# **NORTH PARKES MINES STEP CHANGE PROJECT RESPONSE TO SUBMISSIONS**

Part 3A Environmental Assessment

Prepared by  
**Umwelt (Australia) Pty Limited**  
on behalf of  
**Northparkes Mines**

Project Director: **Barbara Crossley**  
Project Manager: **Tim Crosdale**  
Report No. **2949/R16/FINAL**  
Date: **September 2013**

FIGURE 16b

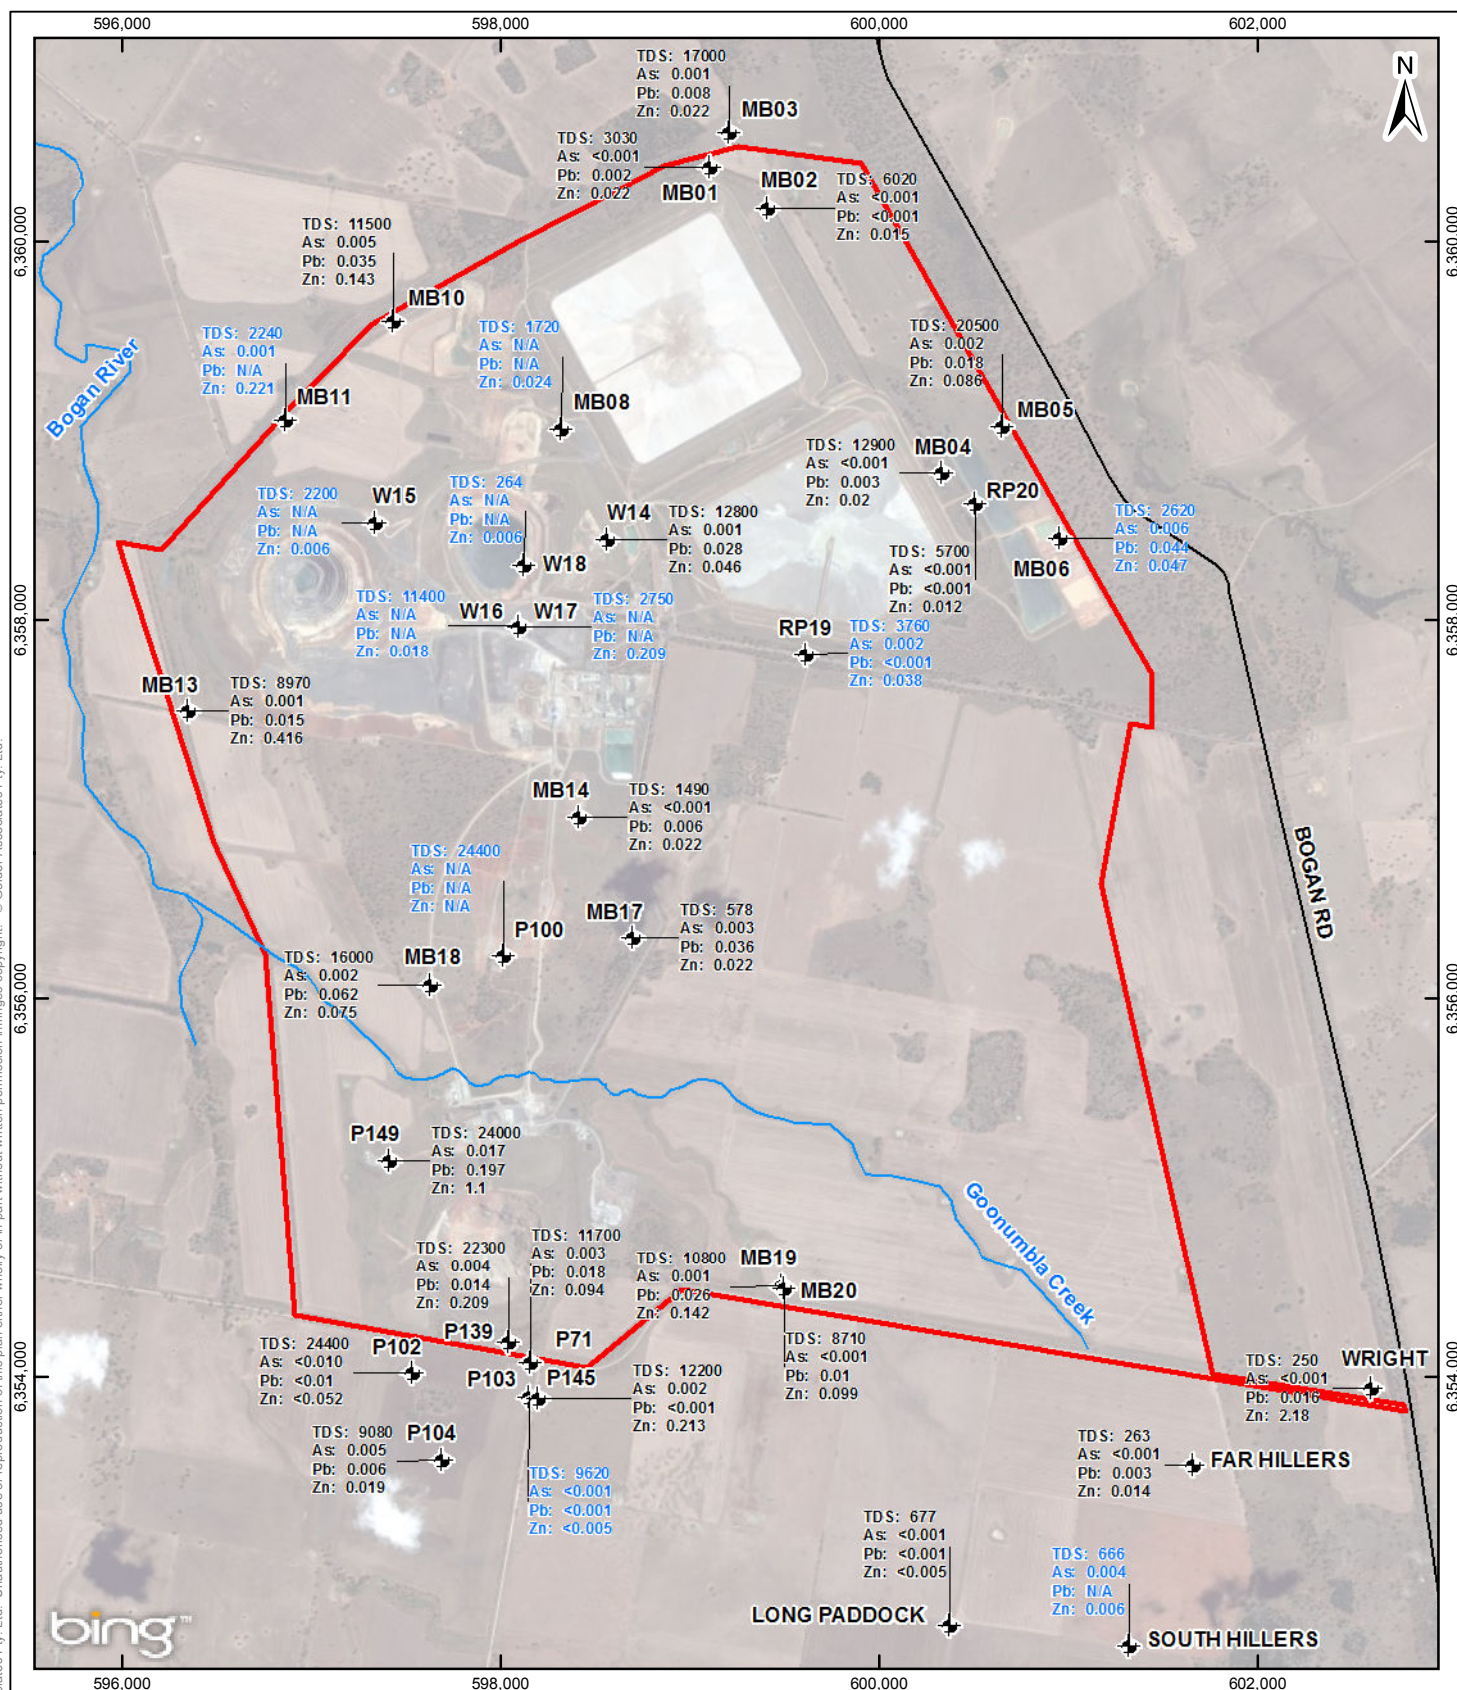
***(vii) Section 4.8.3: required pre-mining and post-mining spatial distribution maps of groundwater quality including at a minimum TDS, As, Pb, and Zn concentrations.***

As requested, additional spatial water quality distribution maps of groundwater quality have been prepared (Please see the new Figure 16b and Figure 16c).

The spatial water quality distribution from NPM regional monitoring bores and the pre-mining sampling site (pre 1993) are shown in Figure 16b. Please note that TDS values are available for some water samples for the pre-mining sampling sites (1983) but there are no data for As, Pb and Zn (Figure 16b). Some sites have no TDS data and some TDS values shown in Figure 16b were converted from the available electrical conductivity.

Figure C8a: Observed and Computed Head Hydrograph for Well W1

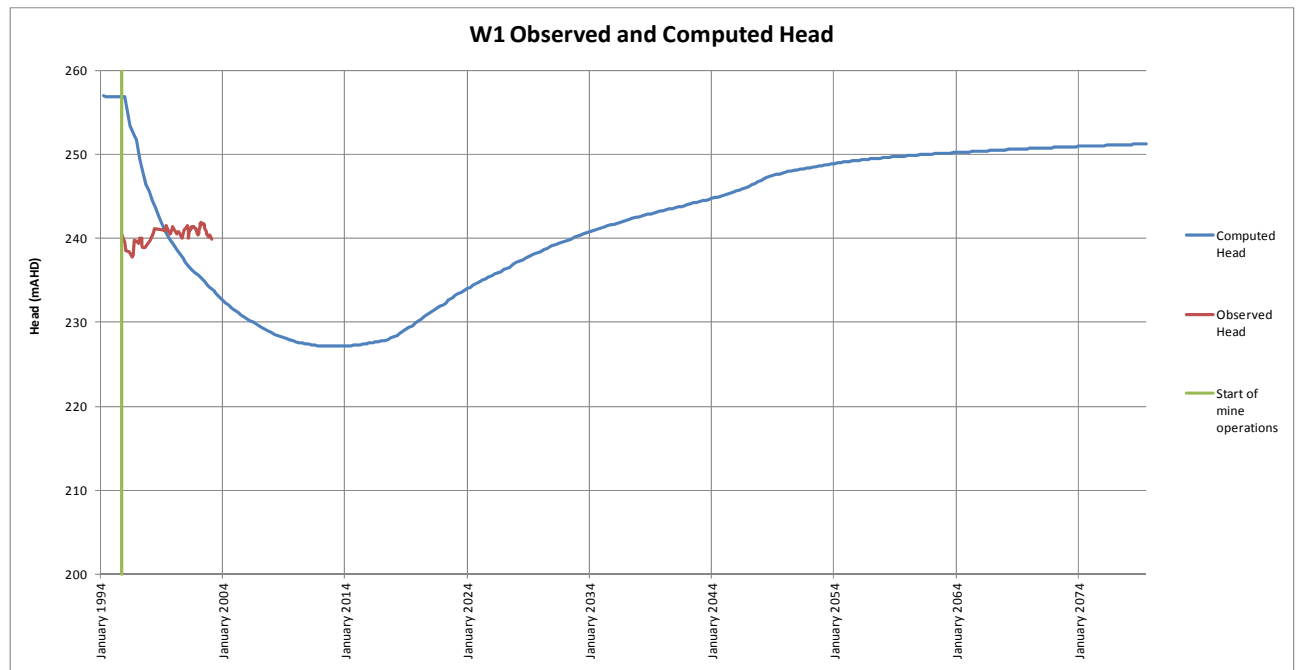
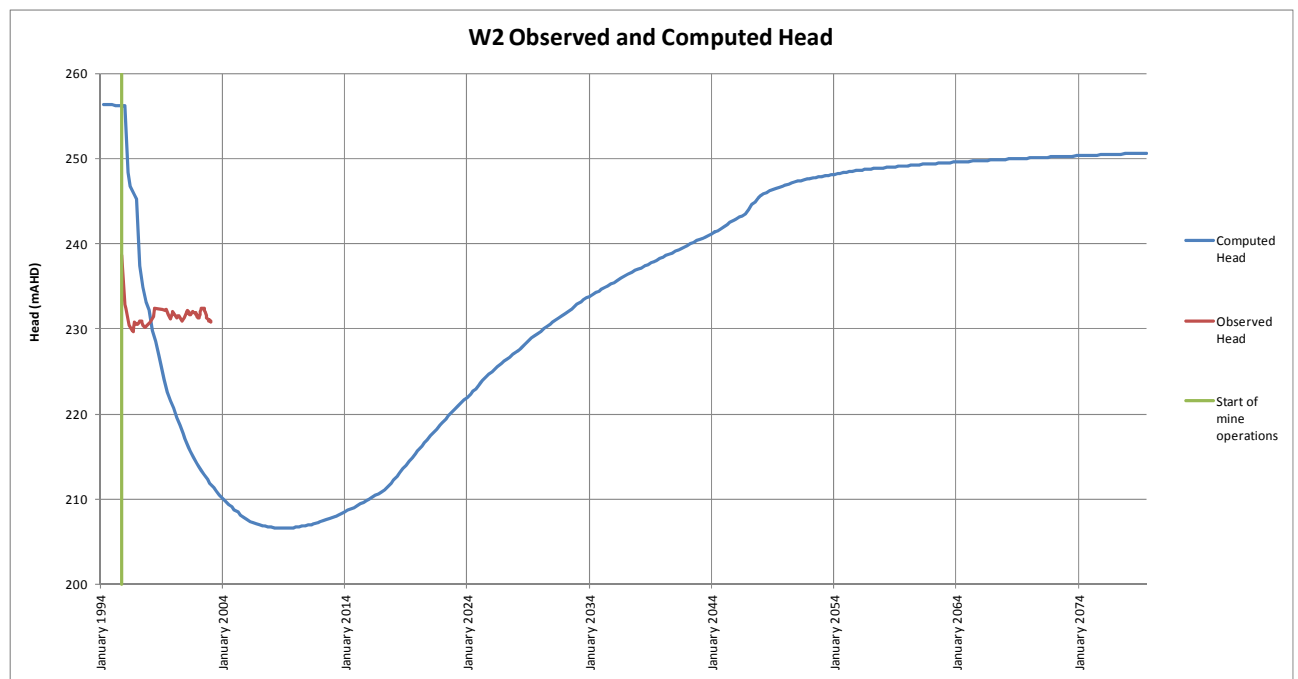
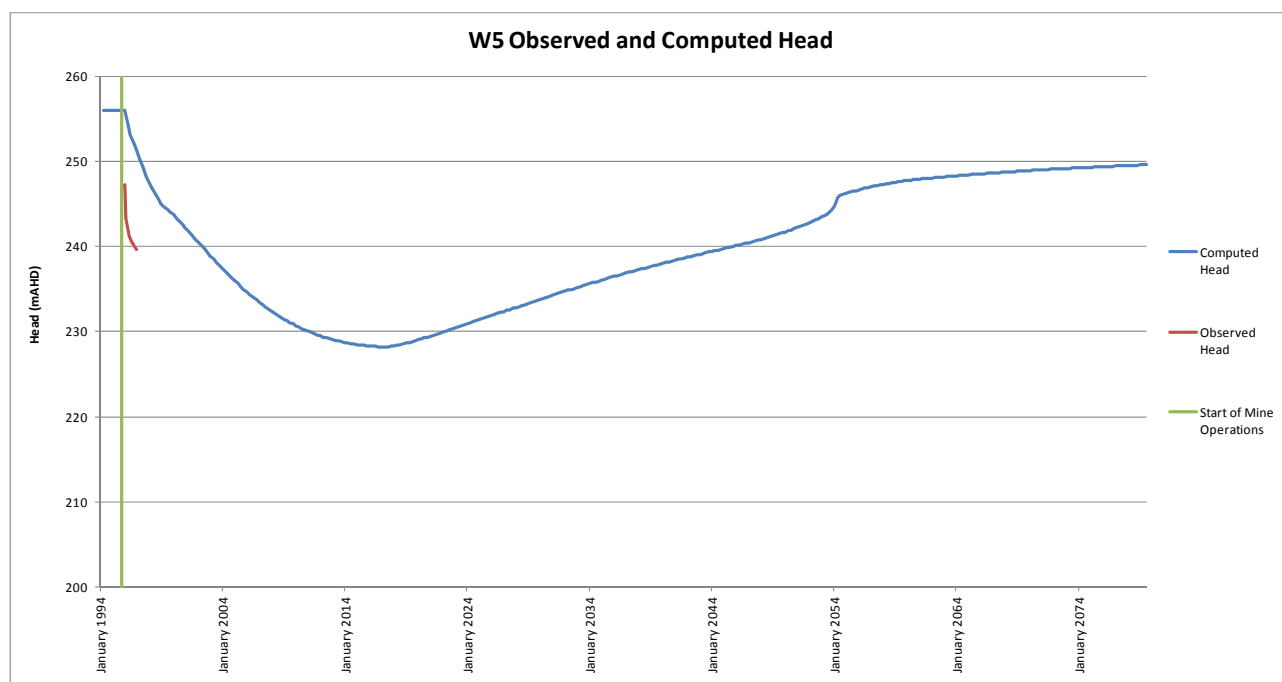
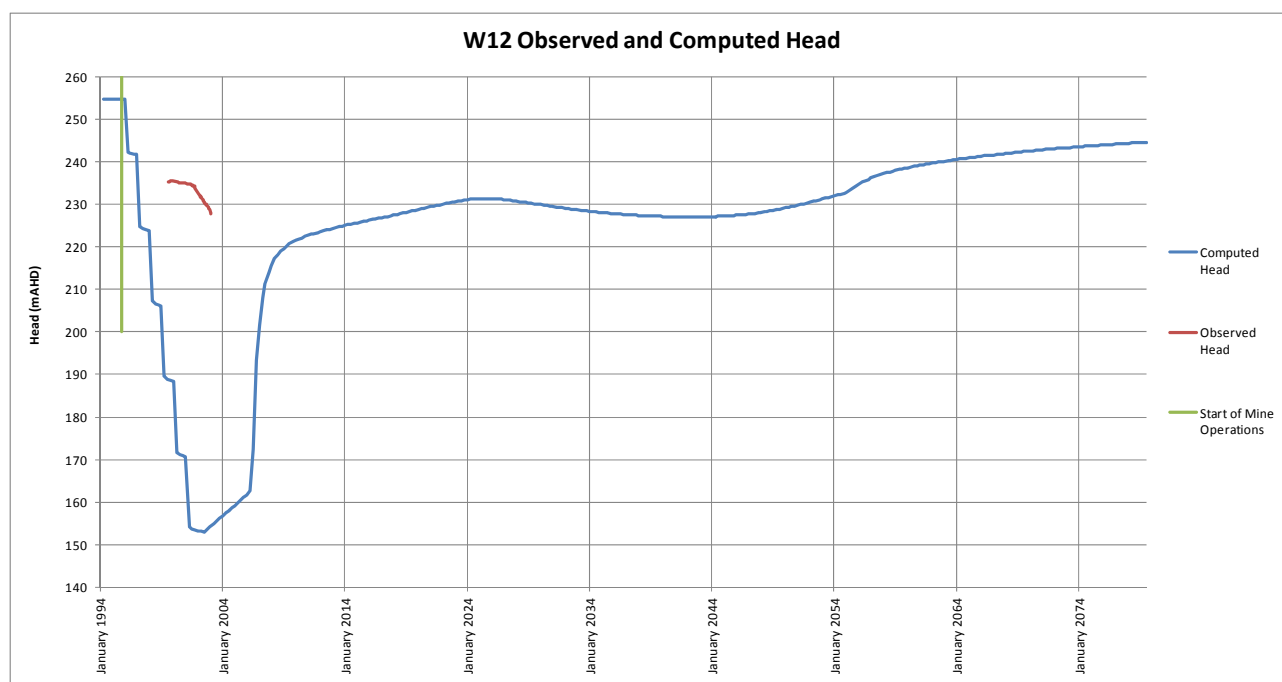
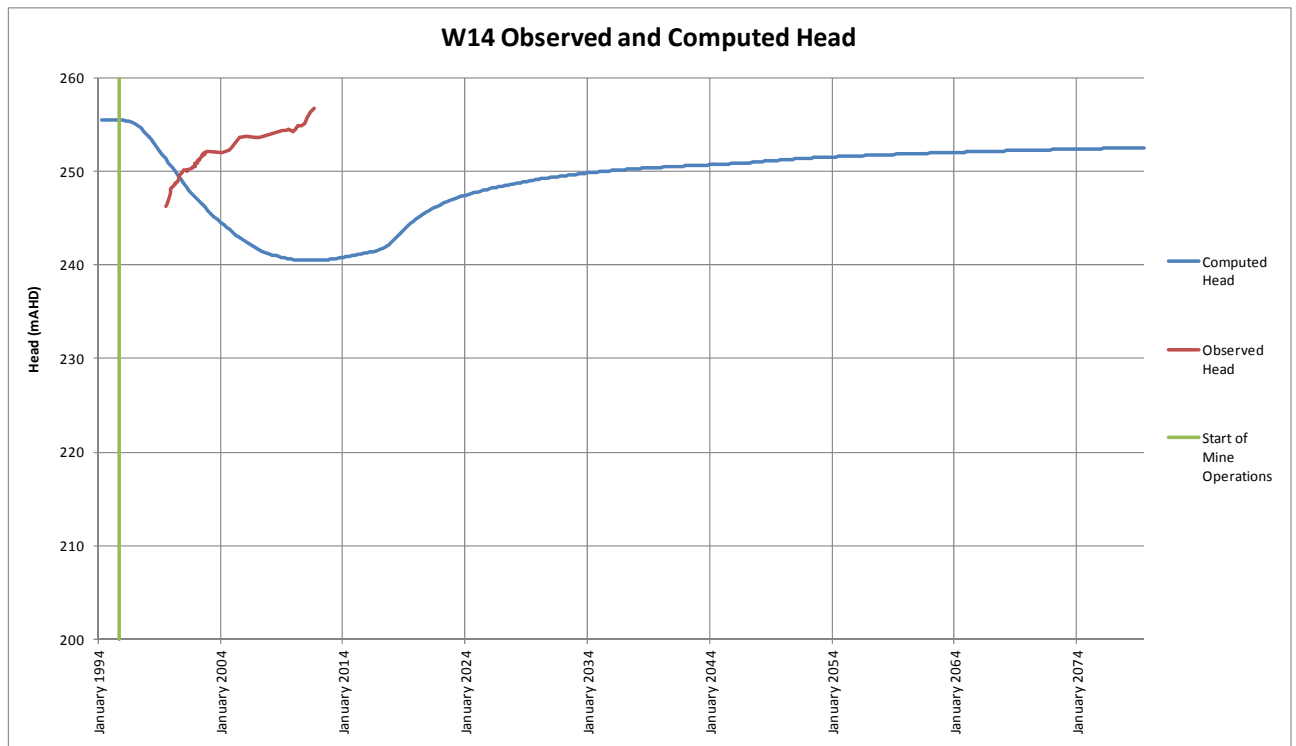
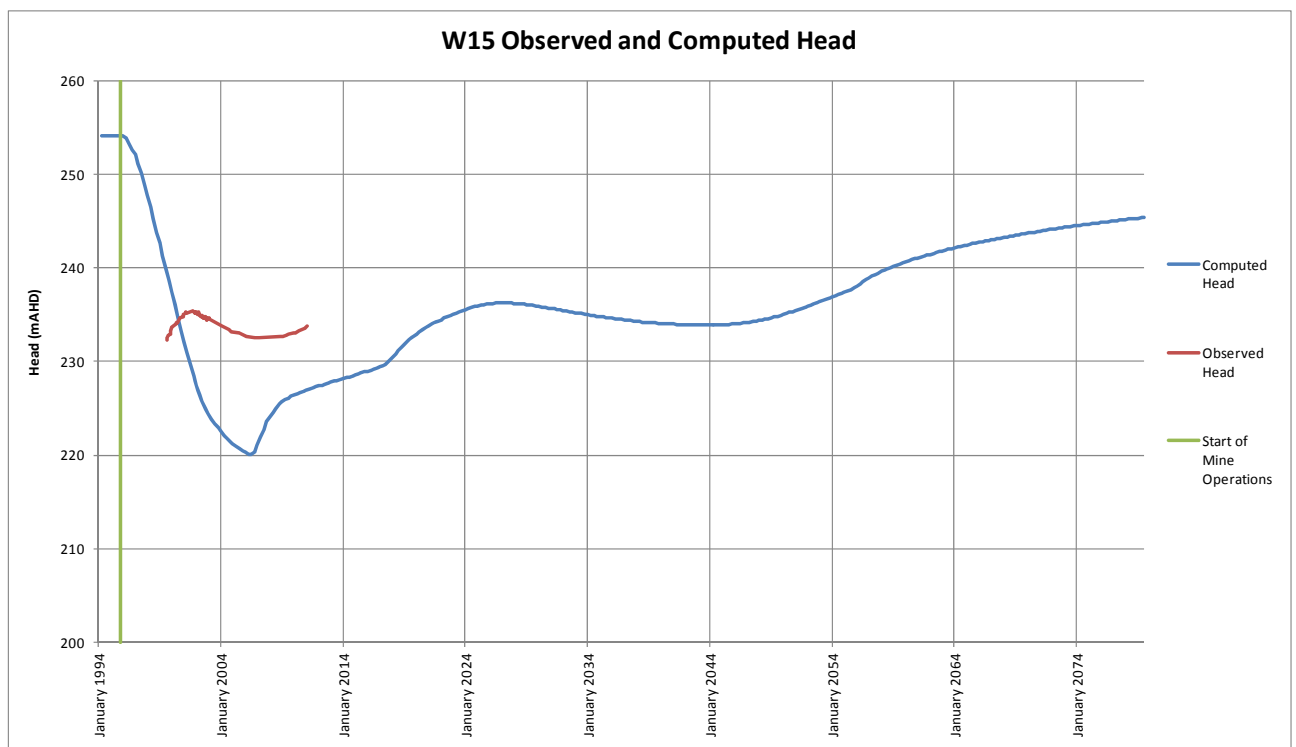
*(ii) Section 2.2.1: Figure C8 – Requires addition of regularized data intervals for each plot, for example Jan 2005, Jan 2000, Jan 2005, etc.*

*(iii) Section 2.2.1: Figure C8 – Requires addition of events such as when mining starts to each plot.*

*(iv) Section 2.2.1: Figure C8 – Vertical scale requires division into reasonable sub-increments, for example 10 m or 20 m.*

*(v) Section 2.2.1: Figure C8 – Asterisk assigned to select bores requires explanation.*

We have revised Figure C8. Regularised data intervals (January 1994, January 2004, etc) were used for each plot. The starting date of mine operations was added to the graphs. The model starts on 1 January 1994. Monitoring in most of the bores started on 12 October 1995.

We have revised Figure C8. The starting date of mine operations was added to the graphs.

We have revised Figure C8. Vertical scale has been revised.

We have revised Figure C8. The asterisks shown on Figure C8 of the GWIA Report are not relevant and we have removed them from the revised Figure in the memo. The asterisks have been removed.

Figure C8l: Observed and Computed Head Hydrograph for Well MB10

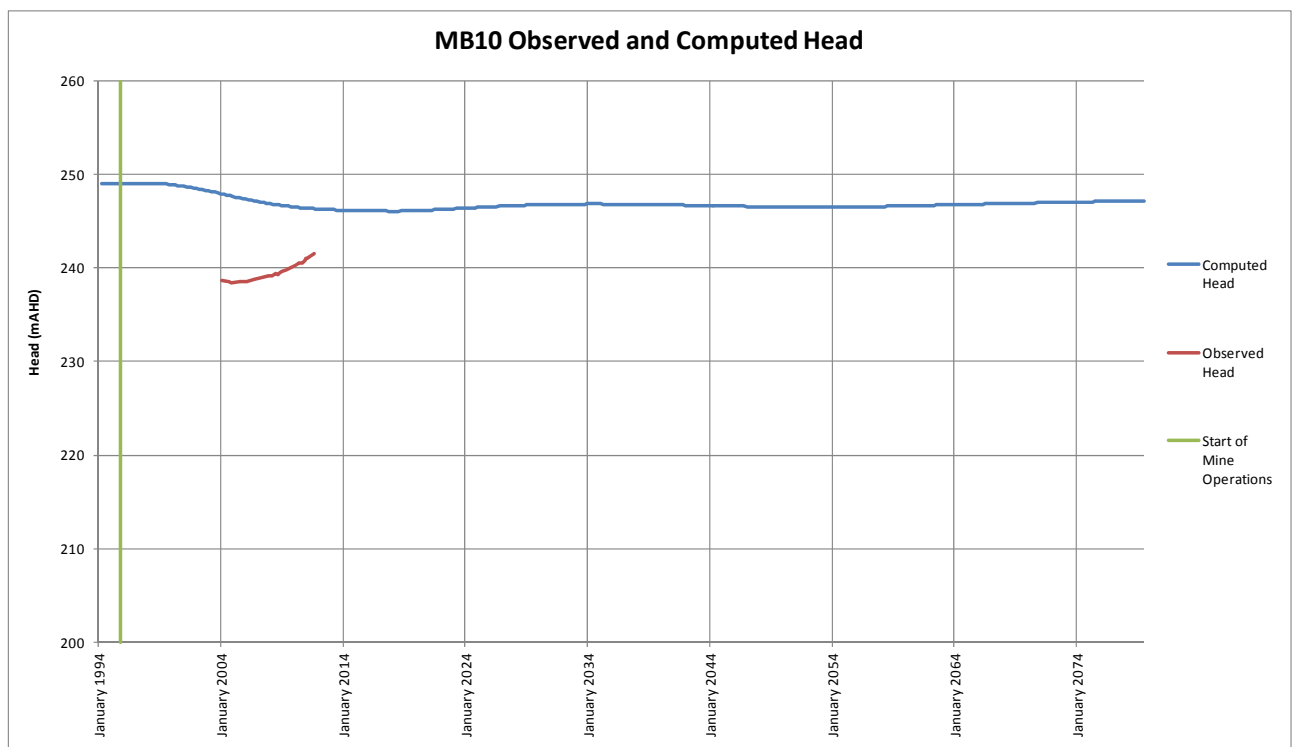
***(vii) Section 2.2.1: Explanation or deletion of comment that groundwater pressure rise is evident from computed measurements in bores MB1, MB2, MB4, MB5, MB13 and MB14 is required. Figure C8 does not indicate level rise in these bores in its current format. In addition, monitoring bore MB10 is mentioned in this section but not included in Figure C8.***

- We have included the hydrograph for MB10 in this memo (please refer to Figure C8l in Section 5.2 of this memo).
- The simulated heads at MB1 and MB2 have increased since 1994 (See Figure C8(h) and C8(i) in Section 3.4 of this memo). At both wells the simulated increase in heads from 1994 to 2013 has been less than 1 m. There has been an overall increase of approximately 2 m in observed heads at wells MB1 & MB2 between 2004 and 2012. Simulated heads are higher than observed heads at both MB1 and MB2. The difference between simulated and observed heads at MB1 decreases from approximately 3 m in 2005 to less than 0.5 m in October 2011. The difference between simulated and observed heads at MB2 decreases from approximately 12 m in 2005 to approximately 10 m in October 2011. Well MB1 and Well MB2 are located immediately to the north of TSF1 and, therefore, groundwater heads at these two wells are affected by the limited seepage of tailings water to the groundwater system. The embankments at NPM are not designed to be impermeable and they allow water to flow through for controlled collection and horizontal drainage (please refer to NPM's response to the question regarding the Tailings Storage Facility Lining in Section 2.3.1.2 of the Response to Submissions Report).

Figure C8r: Observed head and computed head at P139

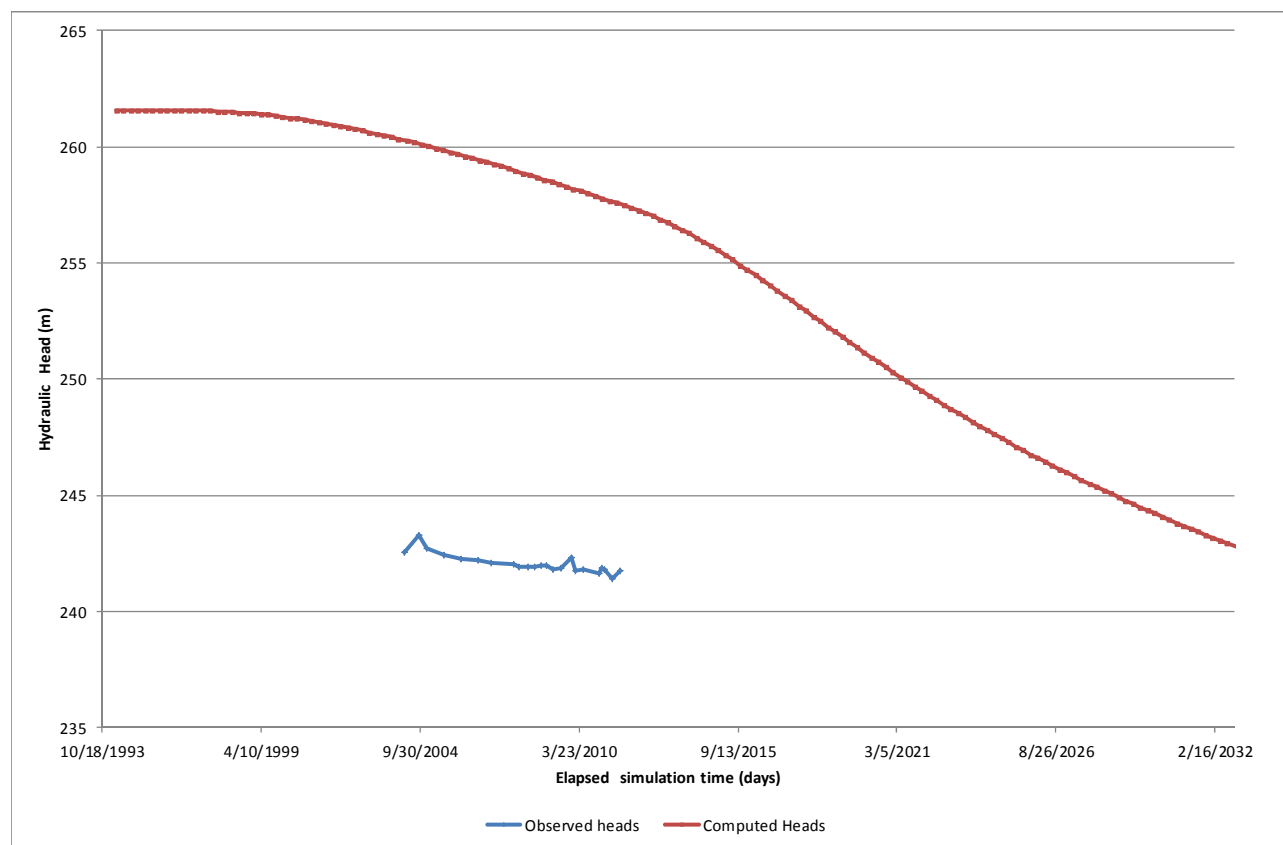
**(x) Inadequate existing monitoring information utilization in the MODFLOW model both east and west of the proposed extension to the E26 resource. As indicated from Figure C7 monitoring bores MB 19/20 to the east of E26 and P139 west of E26 were not utilized as “observation” bores in the model.**

- Simulated groundwater heads at P139 clearly indicate a reduction in groundwater heads in response to dewatering (Please refer to Figure C8(r) below).
